This is to certify that CITY OF PORTLAND / City of Portland / Trades Division has permission to PATHS/CBHS - School Department of - Construction for Code Review AT 174 ALLEN AVE L 343 C013001

**PORTLAND PUBLIC SCHOOLS
PATHS – CBHS
NFPA 101 2003, CODE REVIEW**

**March 3, 2008,
Revised April 1, 2008**

**SECOND FLOOR
EXISTING**

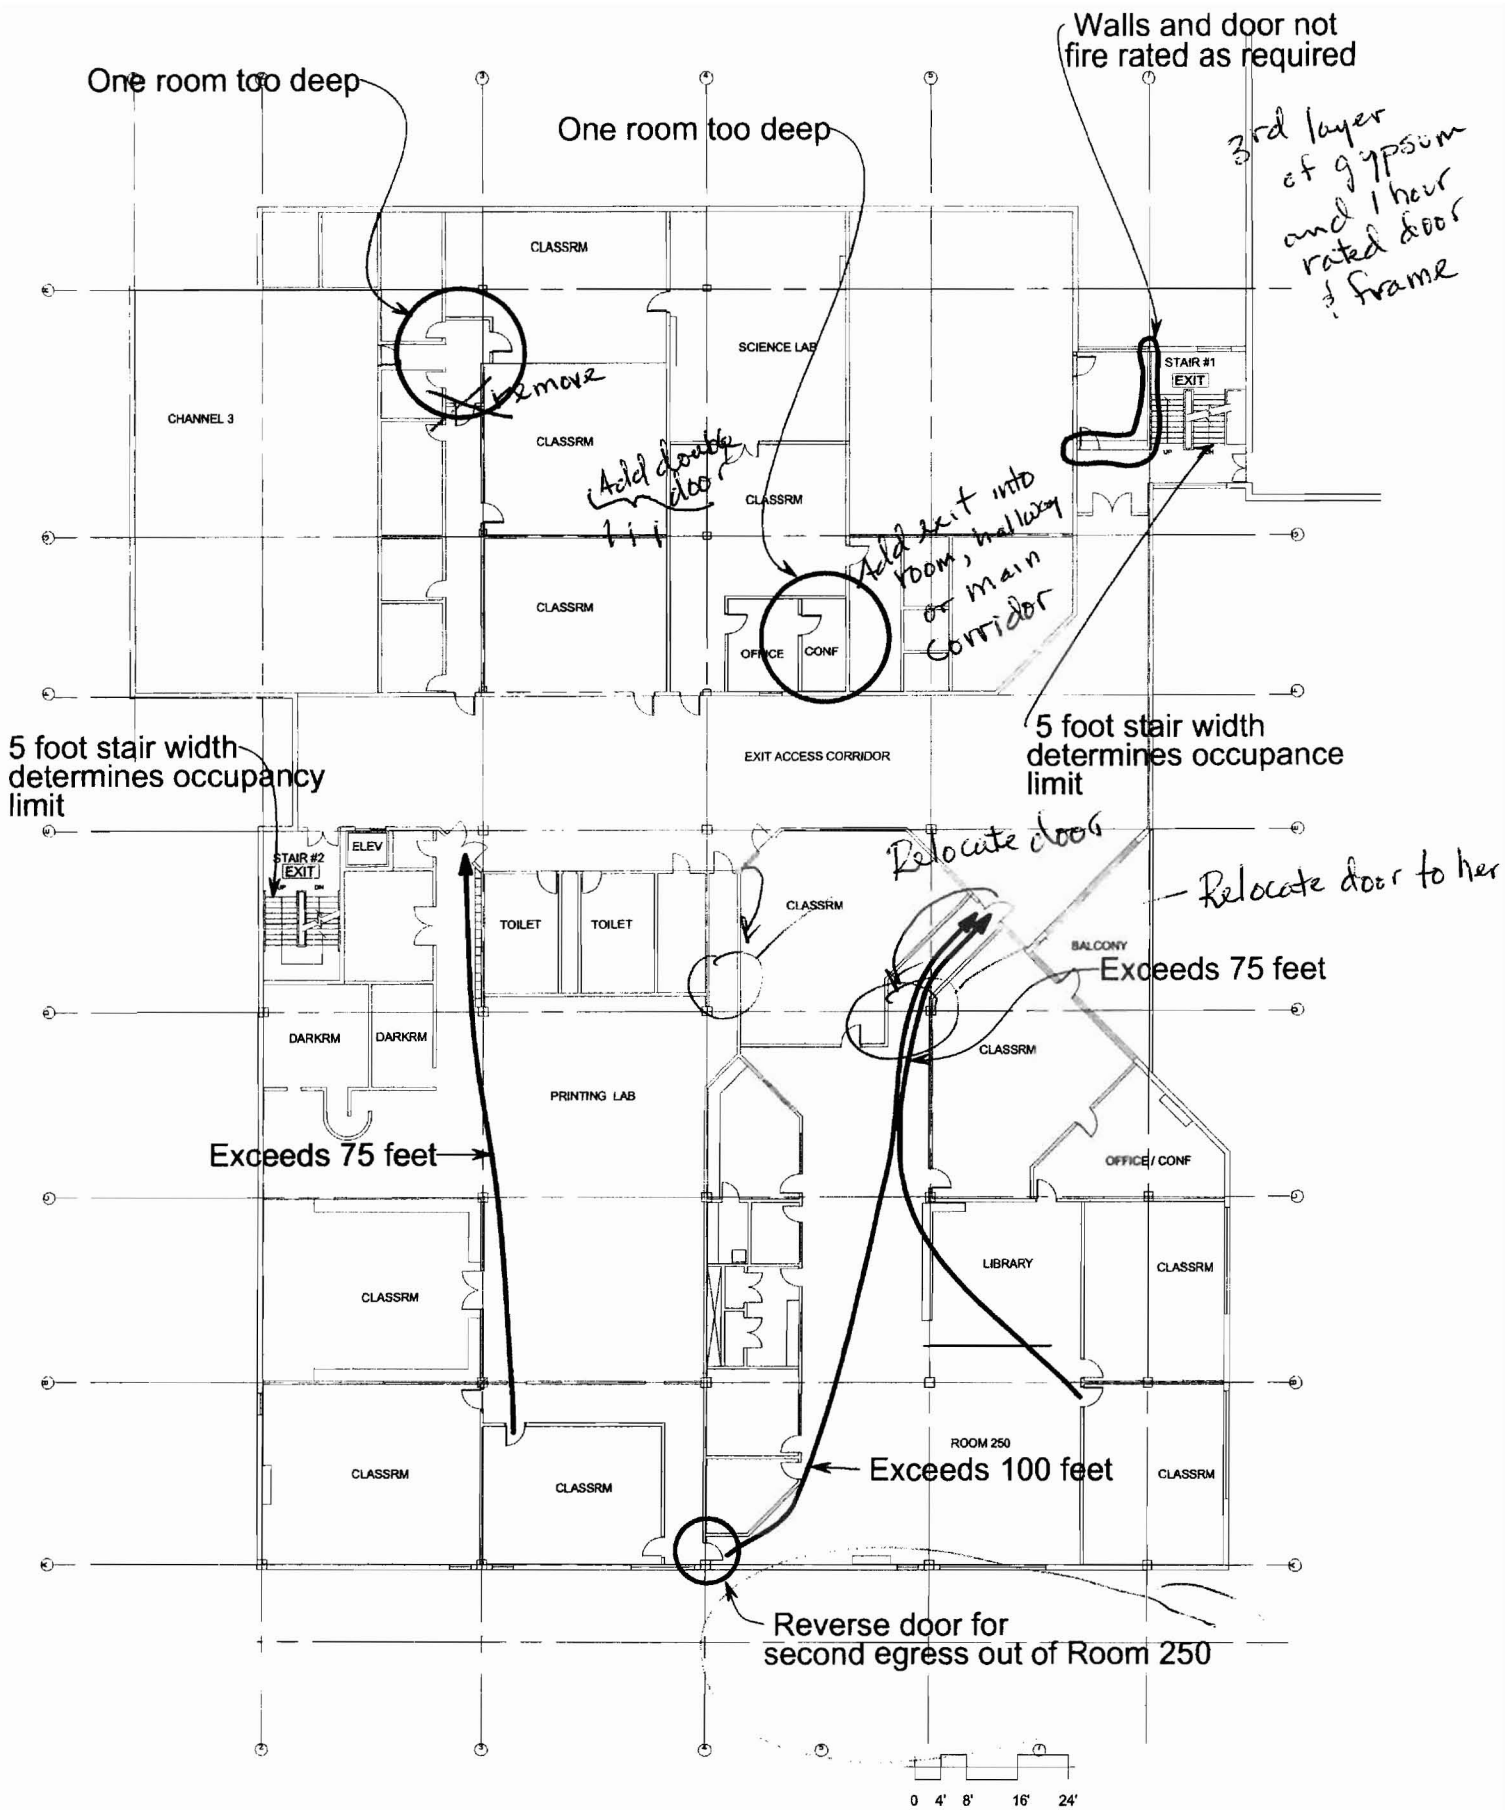
There has been recently the addition of 2 small rooms into the landing areas of the central fire stair, one on each the second and third floors. These rooms have doors that open into the fire stairs. The Code allows "normally occupied spaces and corridors" which these spaces are, to open into the stairs. However, it requires that they be separated by 1-hour construction, including fire doors with closers, to contain any fire in these spaces from spreading into the fire stair which is considered a safe, emergency exit for up to 200 people per floor. See attached drawings SECOND FLOOR EXISTING and THIRD FLOOR EXISTING.

There have been recently five classrooms and an office area created within existing spaces on the north side of the main exit access hallway on the second floor. There are two doors from the corridor leading into these rooms. The door on the east connects to the CBHS office, a classroom and a science room. On the west there is a short hallway that connects to a classroom and several small rooms then opens into another small room that connects to another classroom, several other small rooms and into the Channel 3 studio. There are several issues that will need to be corrected in these areas. See attached drawing SECOND FLOOR EXISTING.

There have been 6 classrooms and one conference room created within the existing spaces on this side of the Exit Access Corridor. To the west there are four classrooms and the conference room placed into the original large multi-use room 250. Currently the room contains the CBHS Library as a defined free standing area within the remaining open area and this room periodically houses the Portland School Committee meetings. See attached drawing SECOND FLOOR EXISTING.

Walls and door not fire rated as required

5 foot stair width determines occupancy limit

**THIRD FLOOR
EXISTING**

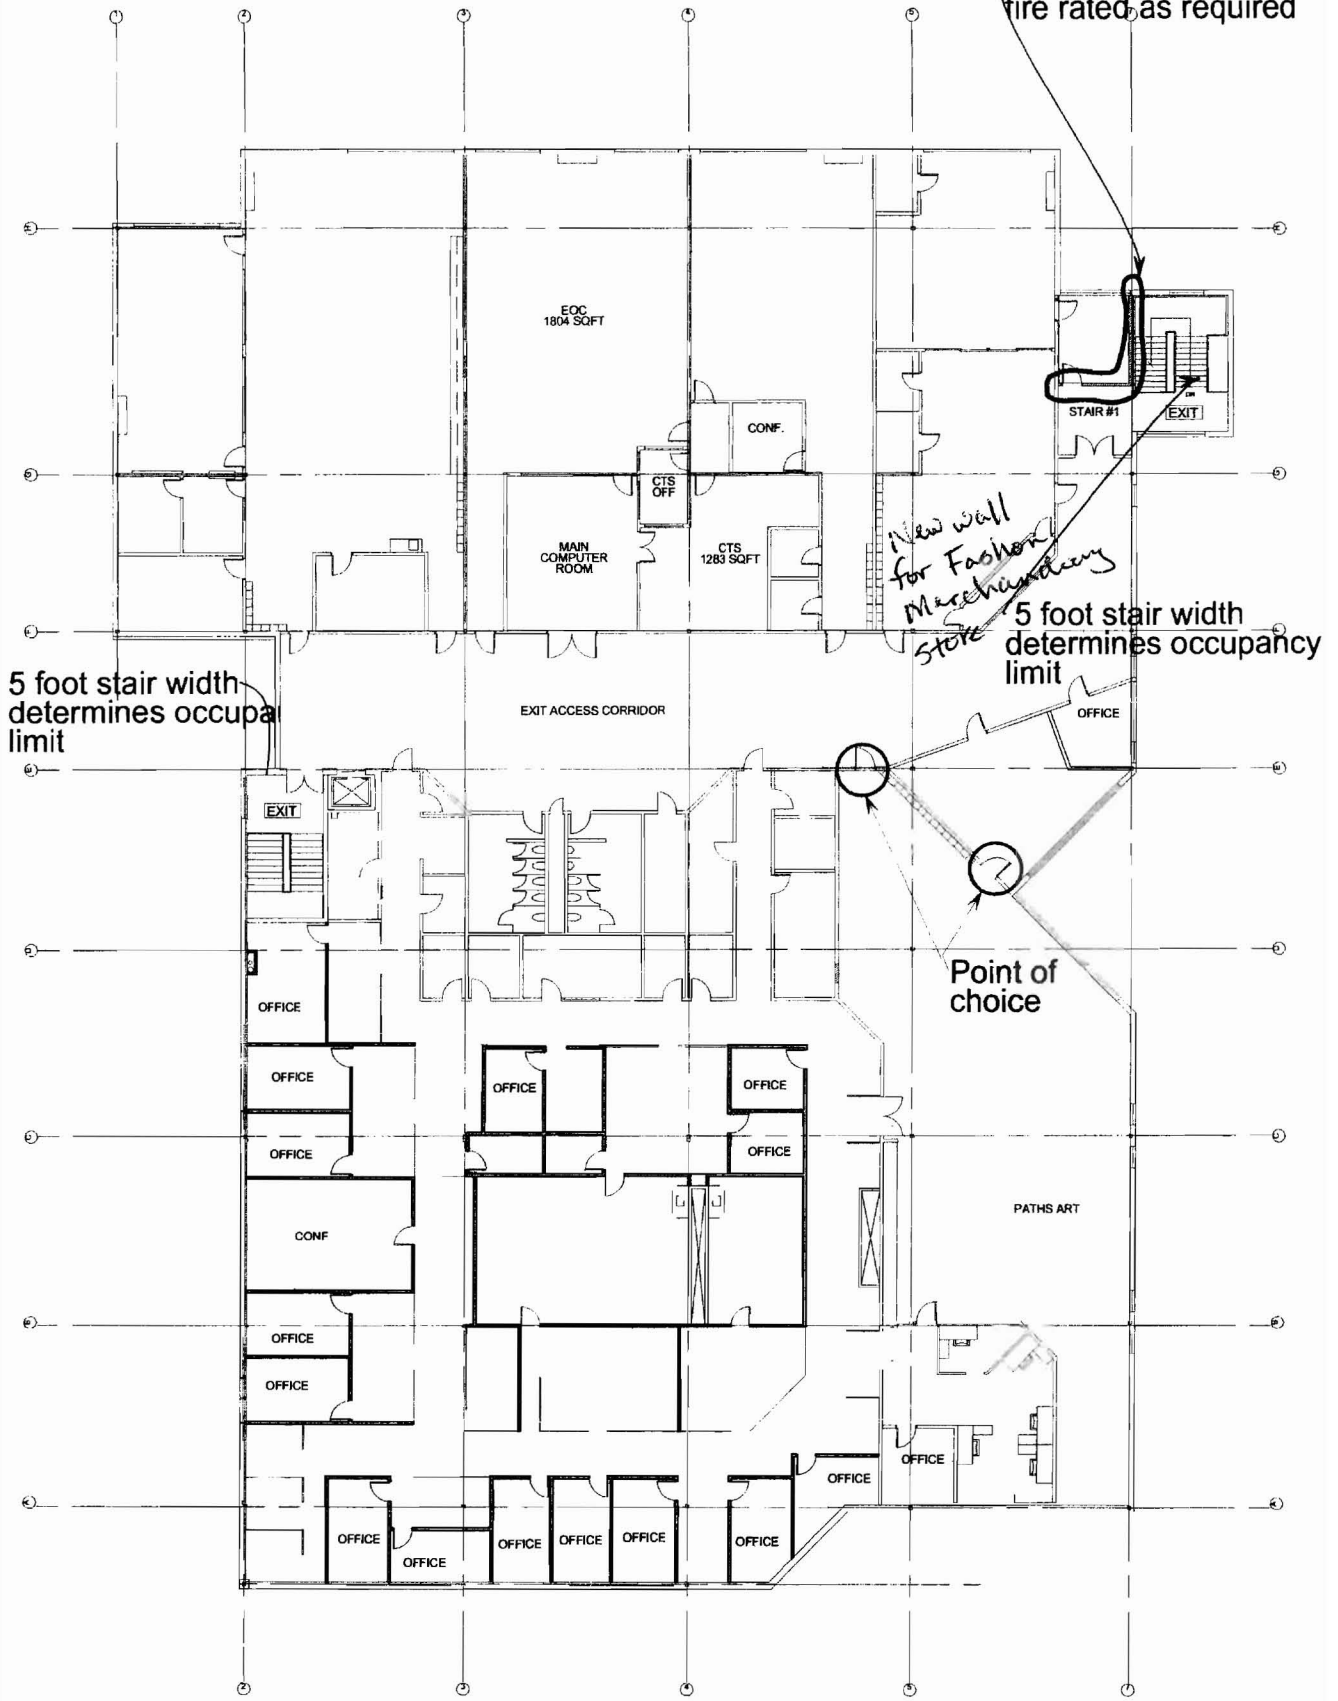
Since the Administration Offices have been constructed, the egress doors between the Art and the office areas have been restricted to deny entrance into the Offices from Art. However, since there is a door into the Exit Access Corridor from this space as well as a door leading into a new classroom, a choice for exiting out of this space exists, making the common path of travel less than the 100 feet maximum. See the attached drawing THIRD FLOOR EXISTING.

5 foot stair width determines occupancy limit

Point of choice

**IMPROVEMENTS
DWG 1 OF 4**

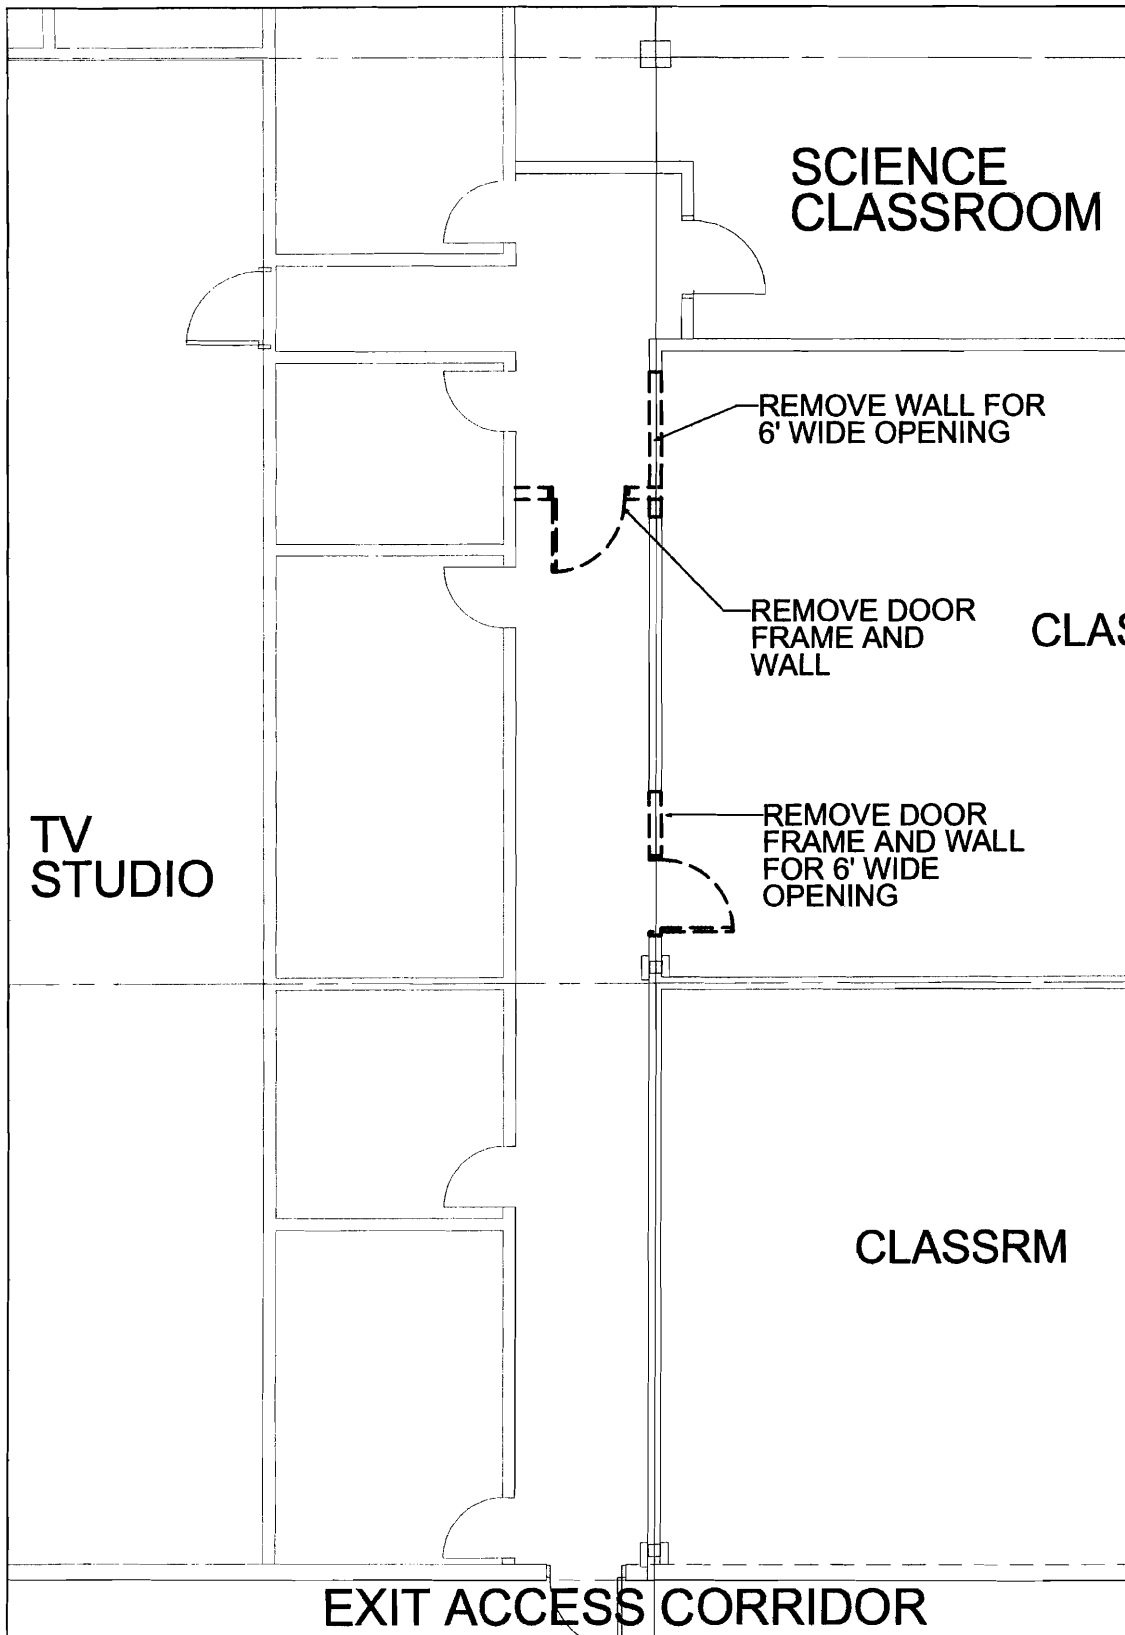
3. On the west side the hallways create a situation where the back classroom is one room too deep. Also the corridor as constructed cannot be made into a part of the exit access since it is only 5'-6" wide instead of the required 6'-0", and a column encroaches even more into that required width. To meet this requirement this hall will have to be reconstructed to the required width, including allowance for the column and the door/wall into the existing corridor will have to be removed for the full 6 foot width. It should be noted that the corridor wall must be a Smoke Partition in accordance with NFPA 101 8.4 but this Section allows construction of the wall to the underside of the suspended acoustic ceiling, and requires closers on all doors opening into it.

- a. Remove the two interior sets of doors and partitions that lead from the hallway to the exterior wall classroom, making that hallway that leads to the Exit Access Corridor a part of that classroom. Thus all spaces would have no more than one intervening room, and the 6 foot minimum width would not apply since it is specific to Exit Access Corridors. Also this change causes the common path of travel to be less than the maximum of 100 feet.
- b. Another option would be to remove the middle door and wall in the hallway, making the hallway the one intervening room between the classrooms and the Exit Access Corridor.

All of these solutions must be reviewed with the local Fire Department. Option b is preferred – see attached drawing IMPROVEMENT DWG 1 OF 4.

**PATHS / CBHS CODE ANALYSIS
2ND FLOOR CLASSROOMS - RECOMMENDED IMPROVEMENTS**

**IMPROVEMENTS
DWG 2 OF 4**

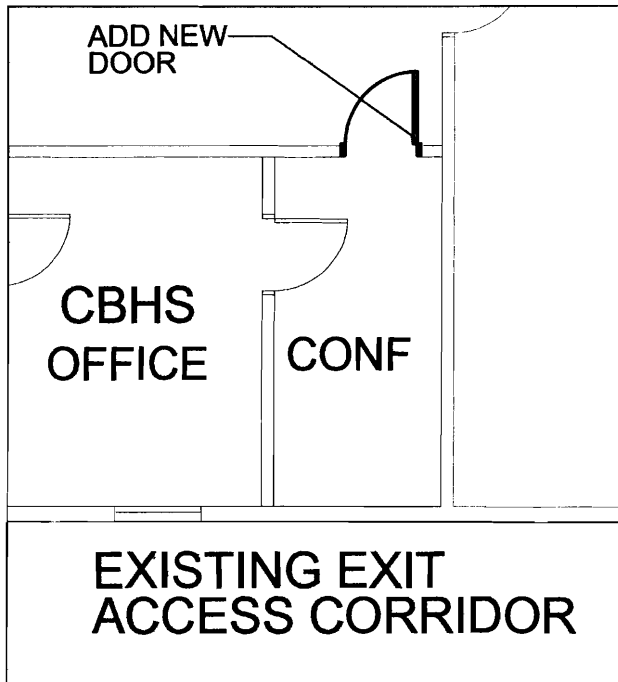
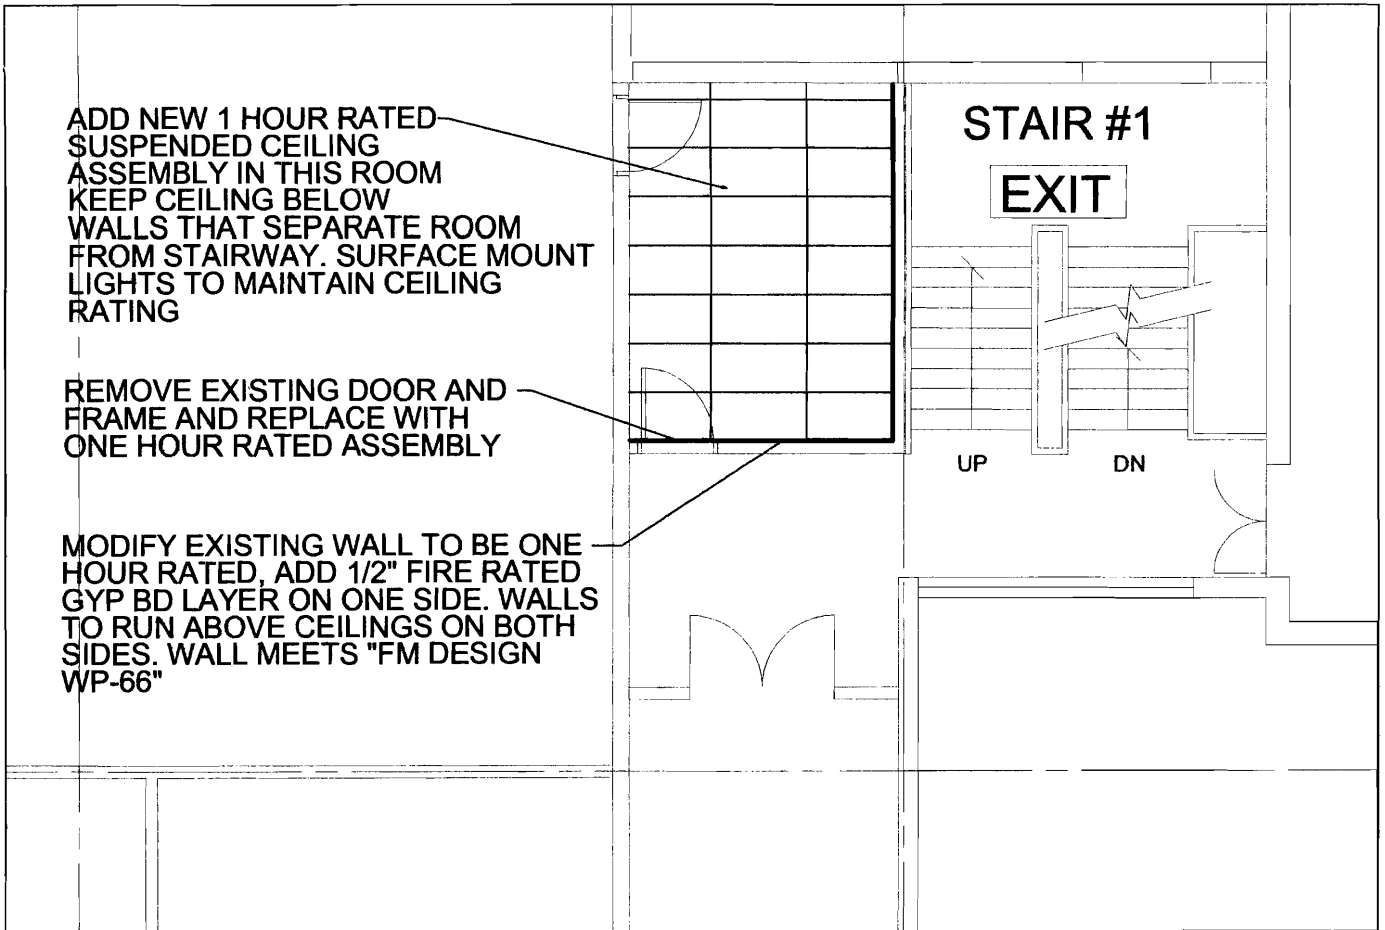
The wall construction of these spaces has been observed to have ½" gypsum wall board on each side stopping at the suspended ceiling, and unrated doors. To achieve 1-hour construction with ½" wall board, the wall board is required to be fire rated and a mineral wool batt blanket insulation bearing Classification Markings as to Fire Resistance be placed to fill the interior of the wall – based on UL Design No. V401. If that insulation is not present, then FM Design WP-66 requires an additional layer of ½" rated wall board to be applied to one side. In either case, the walls will either have to be rebuilt, to the underside of the decks above with appropriate fire stopping at penetrations, or a 1 hour rated suspended ceiling will have to be installed in lieu of the existing. The doors will have to be replaced with a rated door assemblies and closers. It is appropriate to review this construction with the local Fire Department to determine what they deem acceptable for these rooms. See attached drawing IMPROVEMENT DWG 2 OF 4.

1. The Code allows for one intervening room between an occupied space and the corridor. This must meet the following 3 criteria; first that there is 75 feet or less between the room and the corridor door, second that clothing and personal items are in metal lockers or the rooms are sprinklered, and third that there is an automatic sprinkler system in all of the building.
2. On the east side, there is a conference room behind the office; this room will need to have a door added either into the hallway or into the center classroom. The other spaces are set up to all open into the central "intervening" classroom, which is in accordance with the intent of the Code. Also the Office window into the Exit Access Corridor must meet NFPA 80 requirements. See attached drawing IMPROVEMENT DWG 2 OF 4.

**IMPROVEMENTS FOR
STAIR #1 SEPARATION
2ND AND 3RD FLOOR**

**PATHS / CBHS CODE ANALYSIS
2ND FLOOR CBHS OFFICE
2ND & 3RD FLOOR FIRESTAIR #1 - RECOMMENDED IMPROVEMENTS**
